RE: Response to report by Moss Naylor Young

Moss Naylor Young have been appointed by Care4Cary to consider the safety issues related to the new access to a proposed residential development on the north side of the A371 Ansford Hill. A recent automatic traffic count has been undertaken together with speed measurements at the site of the proposed access over a two week period in September 2021. A report was prepared by MNY and this letter responds to the points raised.

Erection of 200 dwellings (70 affordable and 130 open market) with associated highways, drainage, landscaping and public open space. at Land Os 2629 At, Station Road, Castle Cary

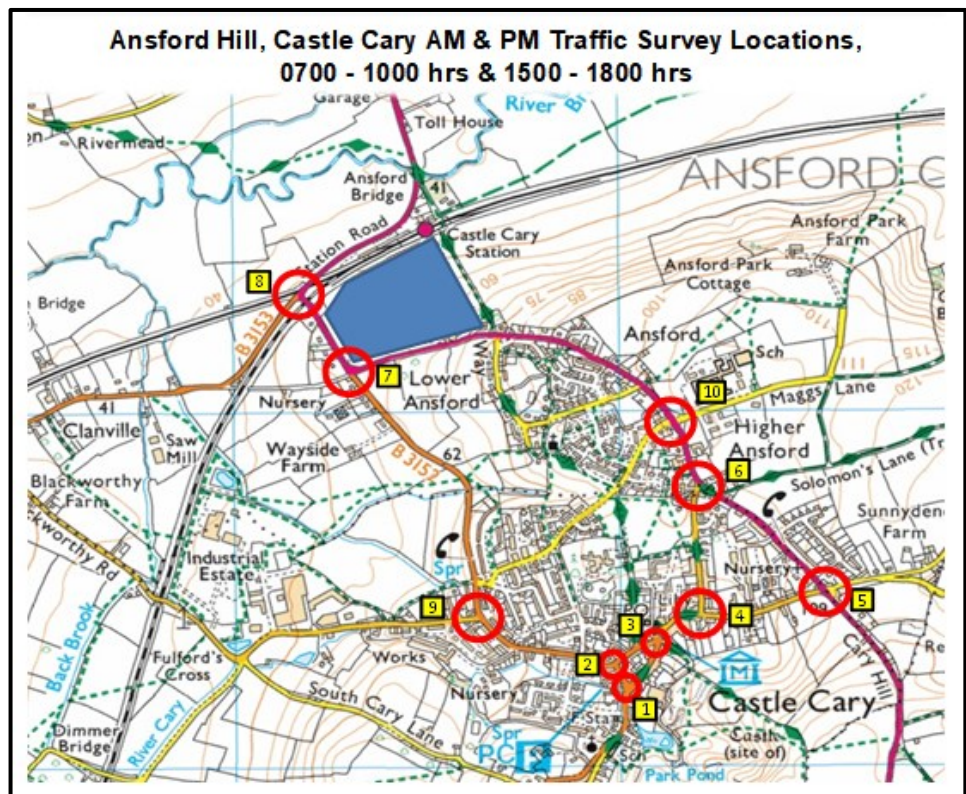
No traffic analysis of the A371 has been included in the Applicant's submission

The submitted Transport Assessment included data from numerous am and pm peak traffic counts as shown in the diagram. This included five junctions along the A371. The peak hour counts in the latest ATC data compares favourably with the surveys undertaken in 2019.

Capacity tests of the site access show maximum queue lengths from the site and in the right turn lane of no more than one vehicle. In total capacity tests were undertaken at four A371 junctions.

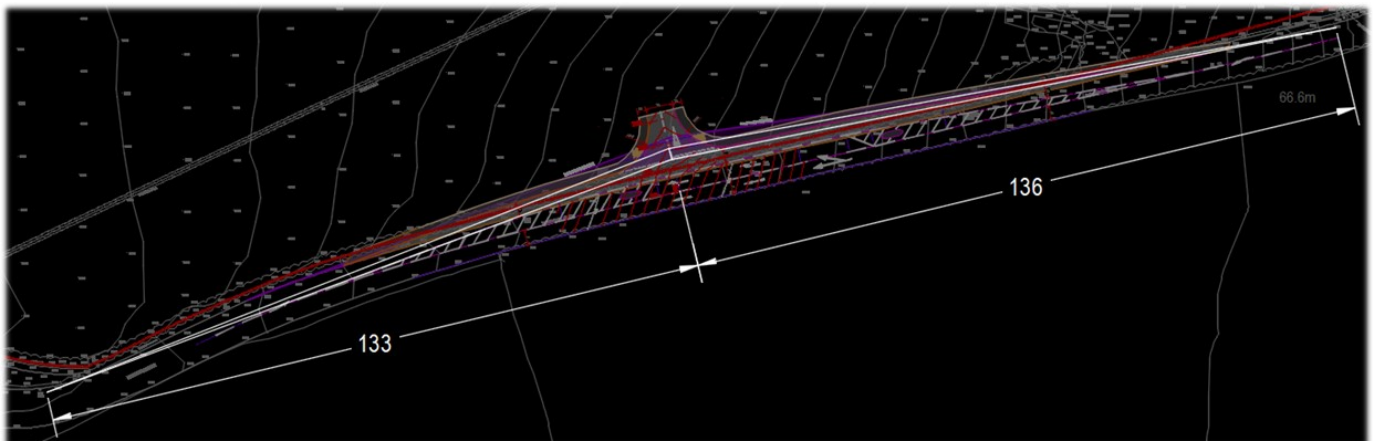
Traffic speeds on the Ansford Hill section of the A371, where the vehicle access to the proposed site is planned, are significantly and persistently in excess of the 30mph speed limit. The volumes, speeds and vehicle mix are consistent through the day and the presence of speeding HGVs causes particular concern.

The observed speeds were shown in the following table.

<u>85%ile</u>	<u>Mean</u>
Eastbound:	39.2mph	33.9mph
Westbound:	40.5mph	35.0mph

Although speed measurements were not taken as part of the Transport Assessment numerous site visits by both LvW Highways and JRC Consultants (responsible for the highway design) confirmed that speeds were often in excess of the 30mph speed limit. As a result of the site visits the design of the access was based on a design speed of 60kph (37.3mph) where a visibility splay of 90 metres is required based on the Design Manual for Roads and Bridges (DMRB) standards. The submitted 'Site Access Layout' indicates the 90m visibility splays at a point 4.5m back from the give way line. With the speeds shown in the table above it could be argued that a design speed of 70kph would be appropriate where a visibility of 120m should be provided. JRC Consulting have checked the available visibility and have confirmed that at a point 2.4m back from the give way line 136m is available to the east and 133m to the west. The design therefore conforms to the higher design speed.

Although speeds have been observed at the location of the proposed site access this does not take account of the traffic calming effect of the two central islands that will be constructed either side of the access. With housing constructed relatively close to the road and a new T-junction the character of the road will be changed and should beneficially reduce the speed of passing traffic. A new 2m wide footway will also be constructed along the site frontage which again will change the character from a rural to a more urban character.
